Bid Addendum

Addendum No. 2 for HRRSA North River WWTF Aeration Improvements ITB No. HRRSA-2015-06, Wiley|Wilson Comm. No. 214256.00.

Addendum Date: July 15, 2015
To: All Bidding Contractors
From: Wiley|Wilson
Lynchburg, VA

PIPE SUPPORT WALL BRACKET

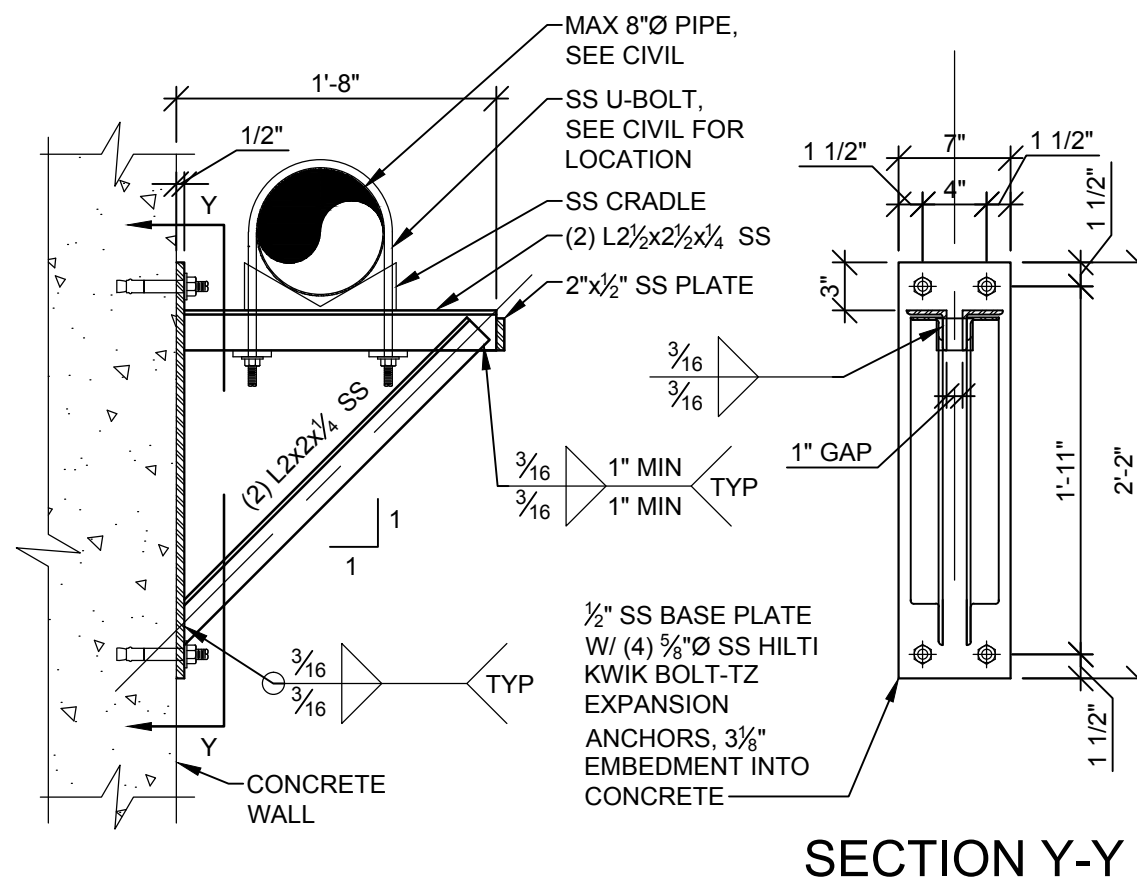
10. Drawing D-501: Replace Pipe Wall Mount Support Detail with the attached SSK-001.
